DEPARTMENT OF THE ARMY  
DETROIT DISTRICT, CORPS OF ENGINEERS  
477 MICHIGAN AVE.  
DETROIT, MICHIGAN 48226-2550

## TO ALL INTERESTED AGENCIES, PUBLIC GROUPS, AND CITIZENS

This notice provides an update on the U.S. Army Corps of Engineers, Detroit District, (USACE) Frankenmuth Dam Fish Passage project, located on the Cass River, Saginaw County, Michigan (**Enclosure Page 1, Figure 1**). An Environmental Assessment (EA) was prepared in 2012 and a Finding of No Significant Impact (FONSI) was signed on November 30, 2012<sup>1</sup>. The purpose of this notice is to provide an update pursuant to the National Environmental Policy Act (NEPA) regarding several modifications to the project: 1) relocation of access road; 2) addition of a floodplain cut; and 3) a minor upgrade to an existing levee/floodwall system.

**Figure 1** – Location map and project overview for the proposed Frankenmuth Fish Passage Project (Oct 2013). North is up, not to scale.

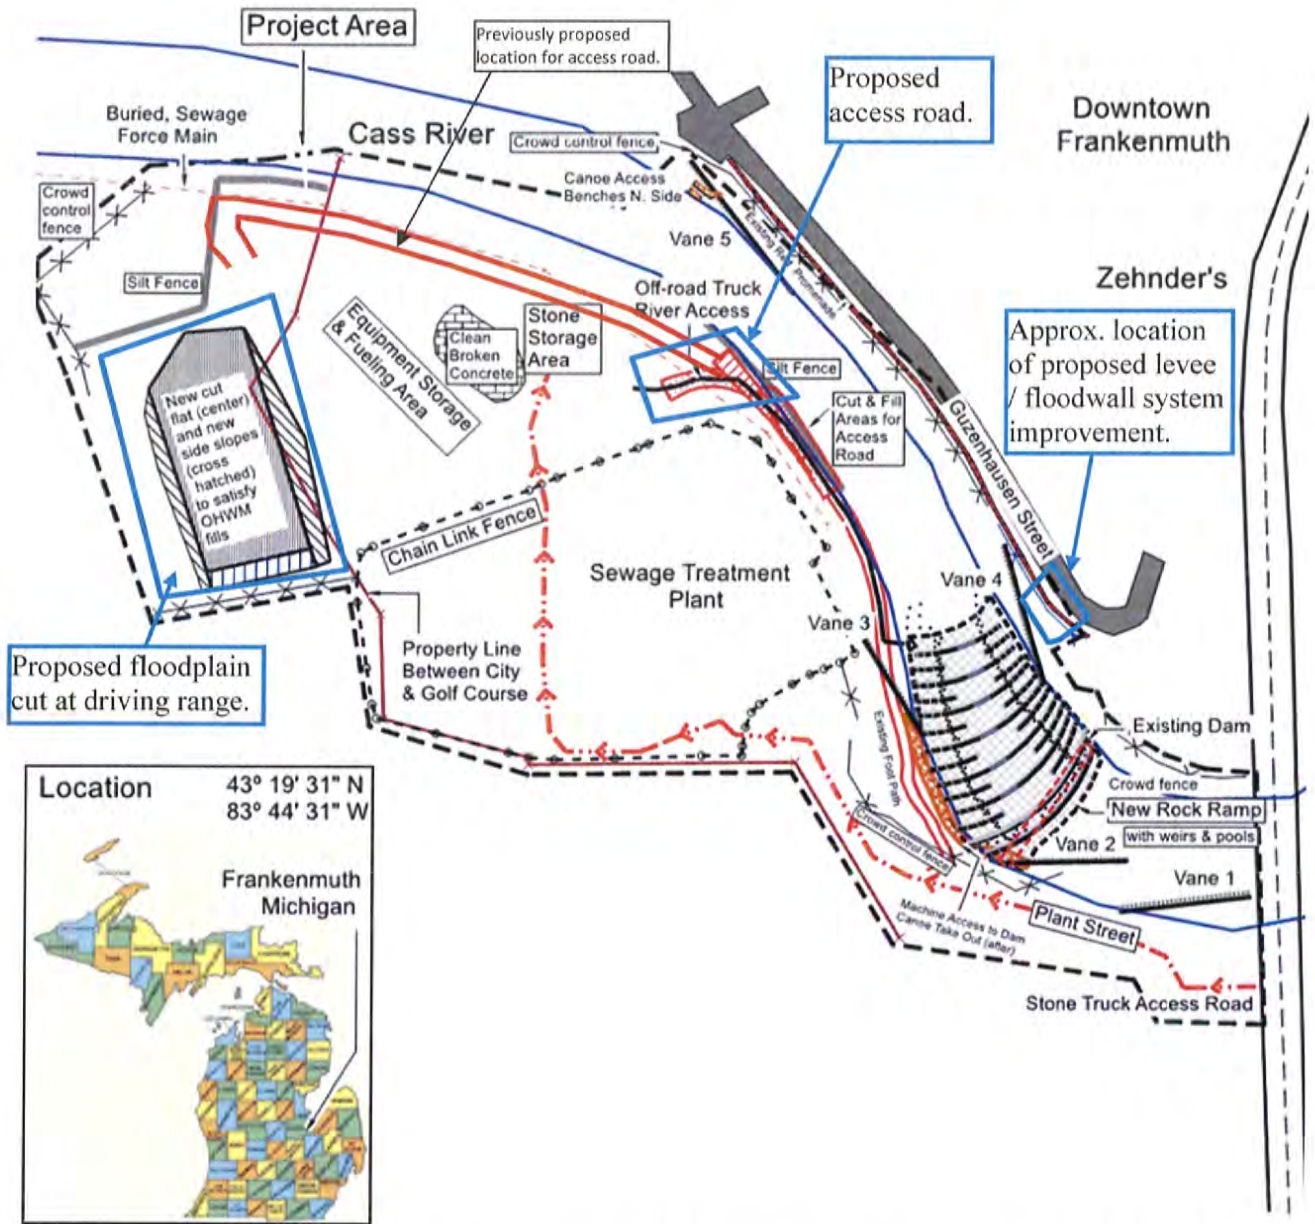
**Access Road:** Upon further study and coordination, it was decided to modify the proposed access road from along the length of the riverbank adjacent to the former landfill, to a permanent access road extending from just north of the City's wastewater treatment plant east, and gradually down and along the riverbank (**Enclosure Page 1, Figure 1**). Relocating the access road reduces the amount of vegetation and land disturbance, as well as reduces the distance construction vehicles must travel to reach the construction site. The access road area is currently a mix of concrete fill, deciduous upland trees, shrubland, and an existing minimally developed path. Only vegetation needing to be removed for road construction will be removed. Minimal cut (approx. 240 cubic yards) and fill (approx. 1,625 cubic yards) is needed to meet required grade and width for the road and to protect existing subsurface infrastructure. Fill along the riverbank to support the road would be a mixture of concrete and/or stone, and match existing and proposed bank conditions in this area.

**Floodplain Cut:** Per Michigan Department of Environmental Quality (MDEQ) Regulations, a compensating cut must be taken for fill placed between the ordinary high water mark (OHWM) and the base flood elevation for the 100-year event. Based on current cut and fill volumes associated with the project, a compensating cut is proposed at the Fortress Golf Course driving range located

immediately west of the project site (**Enclosure Page 1, Figure 1**). The driving range is currently open landscape vegetated with grass. The proposed cut will be approximately 8,220 cubic yards, covering an area of approximately 0.77 acres (280' by 120') with excavation depths up to 2 to 5 feet. The cut area will be re-vegetated with grass to match existing conditions and will continue to be used as a driving range. The excavated material will be placed at the former landfill site above the 100-year flood elevation.

**Figure 2** – Location of proposed levee / floodwall system improvement as part of the proposed Frankenmuth Fish Passage Project (Mar 2014).

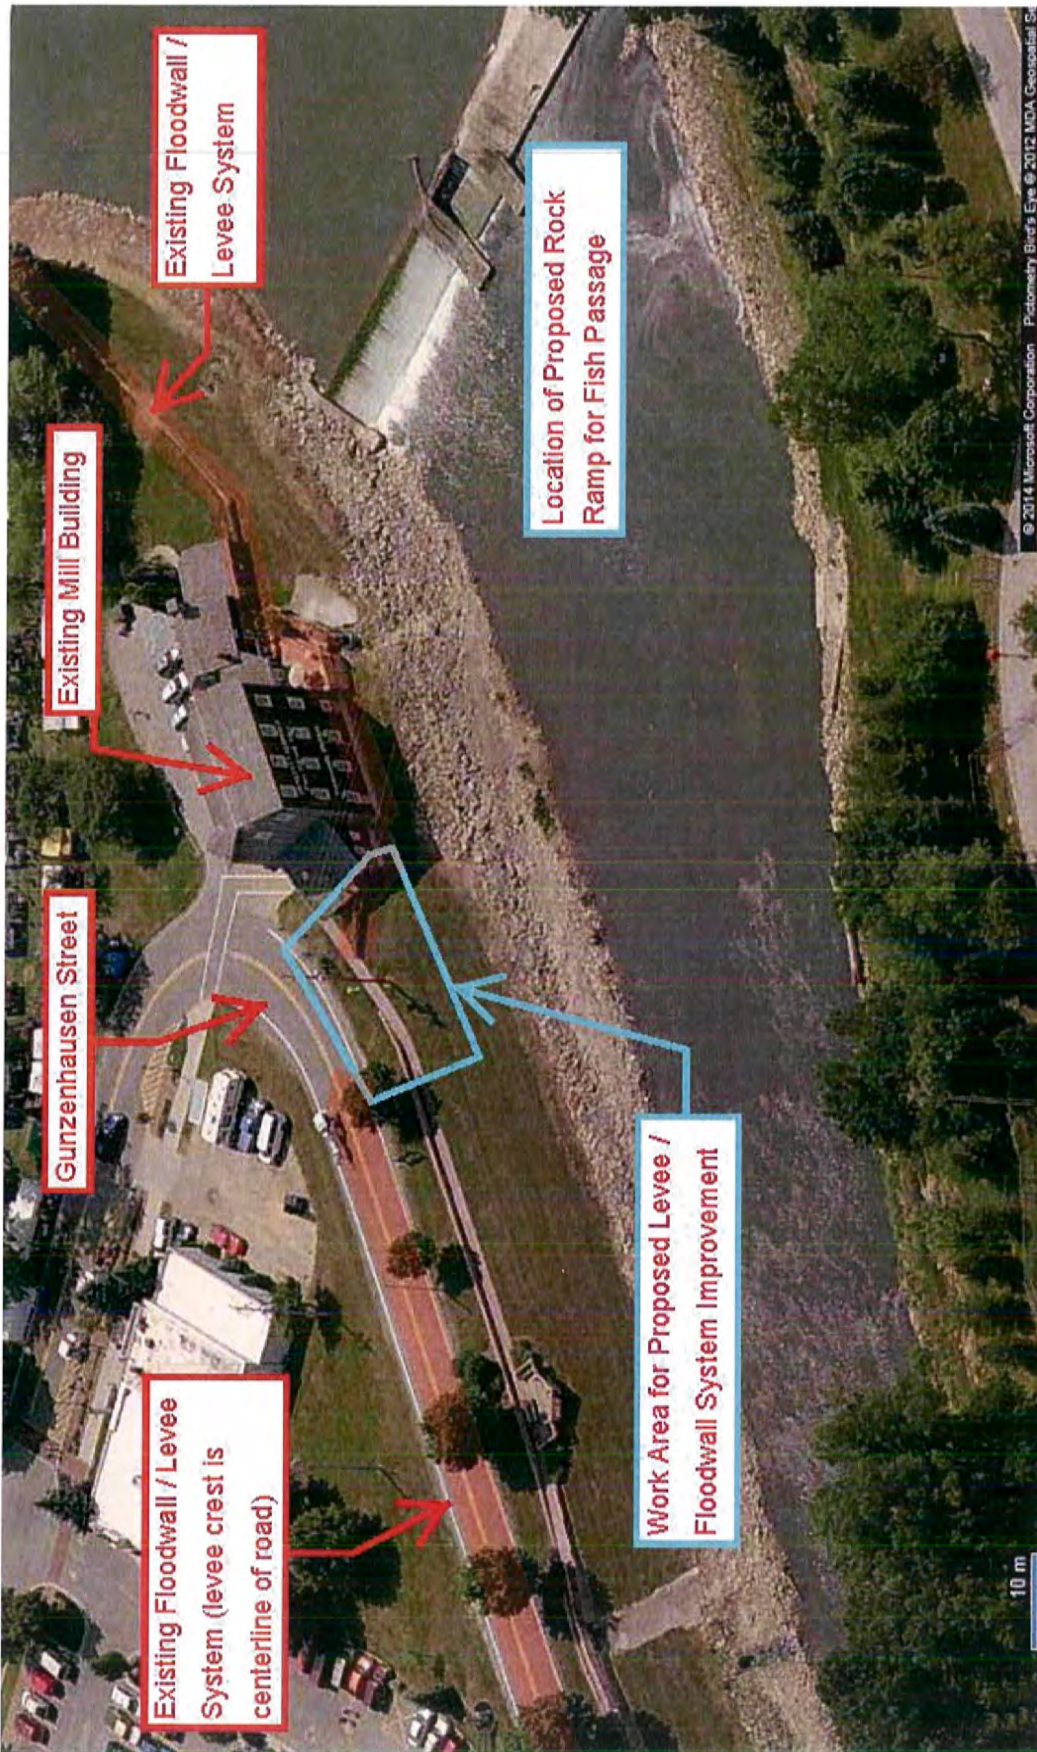
Upgrade of Existing Levee/Floodwall System: After coordinating the project and hydraulic modeling for the proposed project with the MDEQ Floodplain Management Office, Water Resources Division, it is proposed to convert a sand bag closure located between the existing Federal floodwall/levee system and mill building to a permanent floodwall/earthen levee feature. This feature would provide flood protection to the base flood elevation. The proposed improvement would convert a sandbag closure to a permanent levee/floodwall barrier along an approximately 65 foot wide area between the existing levee and mill building (**Enclosure Pages 1-2, Figures 1-2**). The current concept plan involves raising an existing retaining wall, constructing a new retaining wall, constructing a pedestrian ramp, and constructing a new floodwall between the proposed ramp and existing mill building (**Enclosure Page 3, Figure 3**). The area is currently occupied by grass and a sidewalk.
